Final 2015 Annual Sampling Report

Groundwater Monitoring and Data Analysis at the Landfill Source Area

Operable Unit 4 FTWW-038 Fort Wainwright, Alaska

RE	EVIEW	PROJECT: Fort Wainwright				
1	DMMENTS		toring Report, (DU-1, ADEC File No. 108.38.068.08		
ENVIRONMENTAL REVIE			Action taken on comment by: Karol Johnson

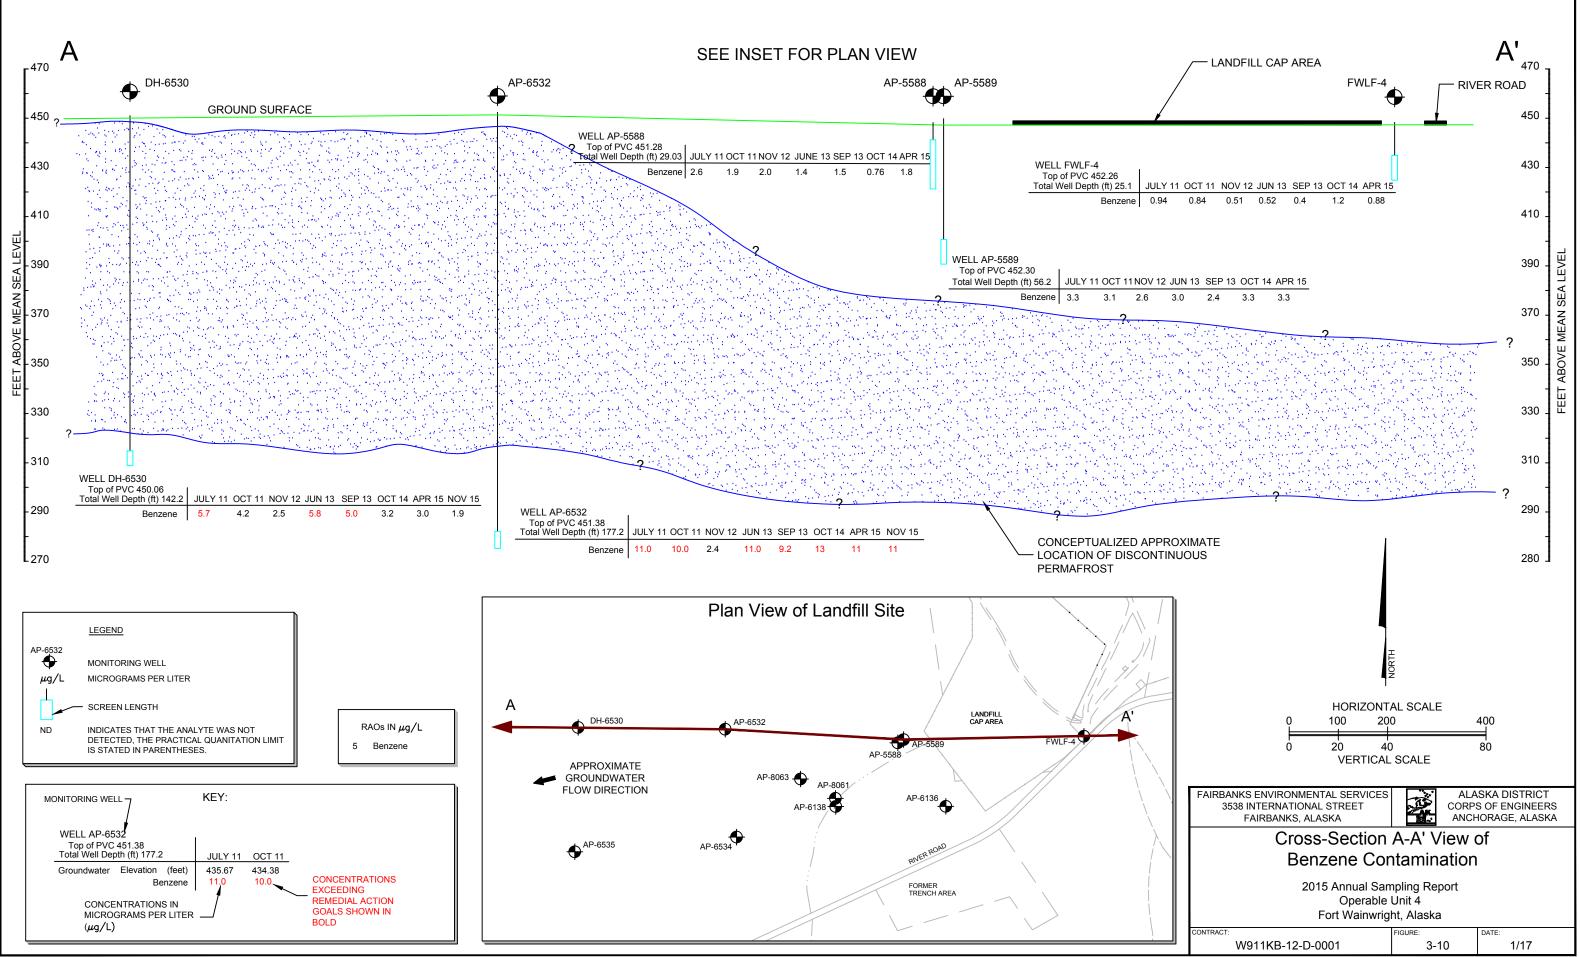
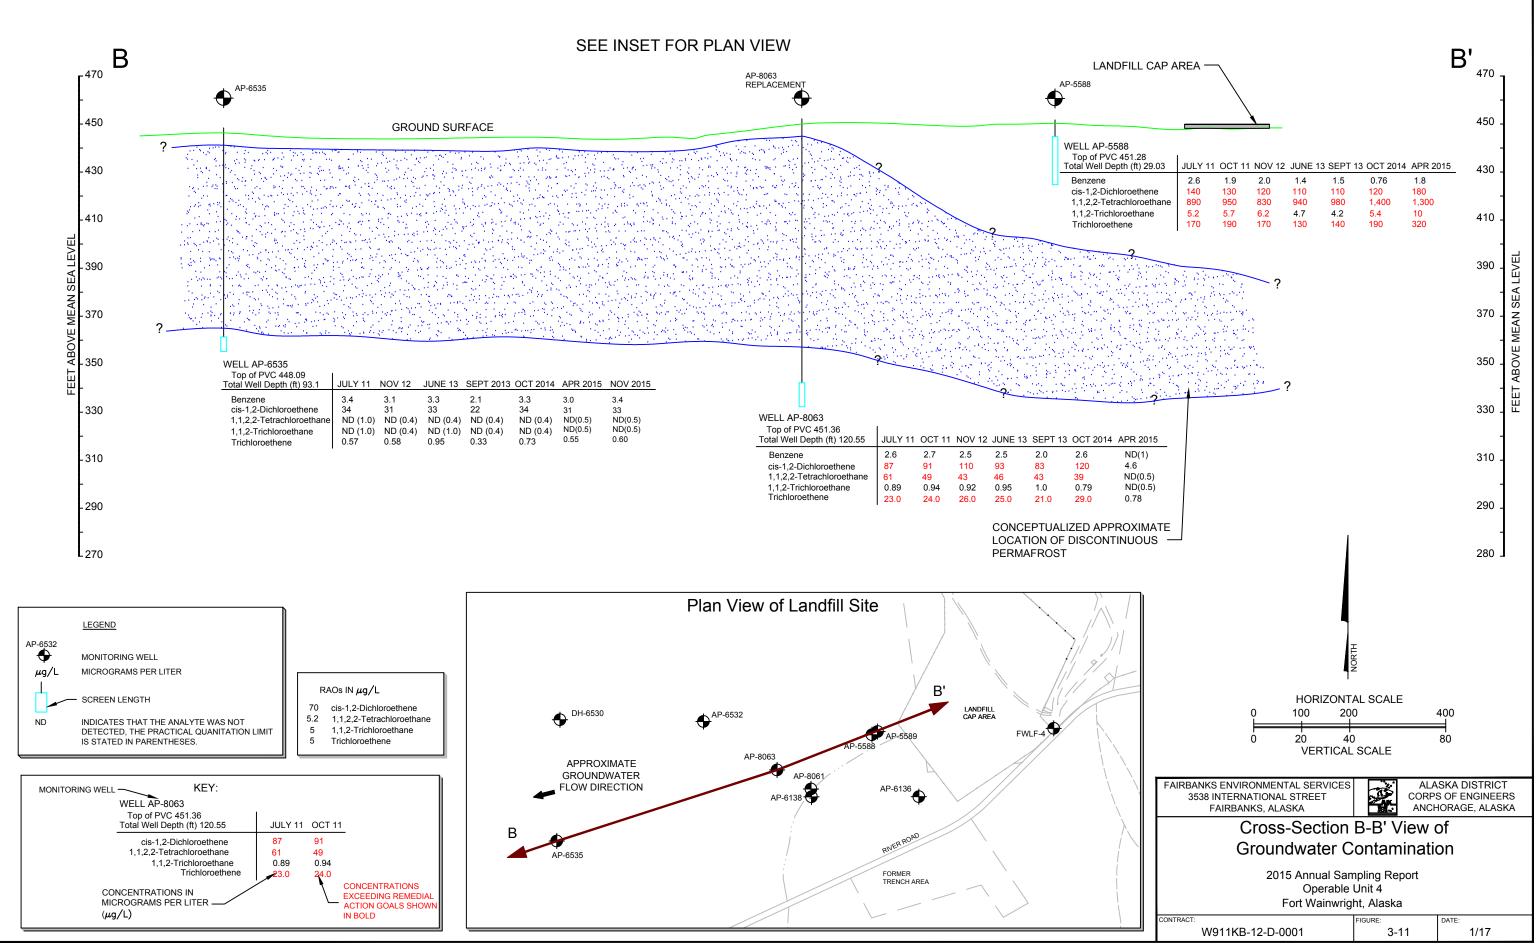
23	Figure 3- 10 and 3- 11	These CSM figures are very illustrative and well done. is the permafrost block changing over time and affectir plume migration? If we don't have a means to measur that on intermittent intervals, it should be considered.		fecting easure	Noted	Currently the change in the permafrost block over time is not measured. This suggestion will be presented to the RPMs.	A
24	53 5.0 AP-5588	 that on intermittent intervals, it should be considered. The sample frequency at this well was reduced to an spring sampling in 2015 because historically COC concentrations have not varied significantly between spring and fall sampling events. It would be very helpful to plot the concentrations of only, and a separate of fall only, before making these 		annual en the of spring	Noted	Reducing the sampling frequency of AP- 5588 was approved in the 2014 OU4 Monitoring Report.	Noted
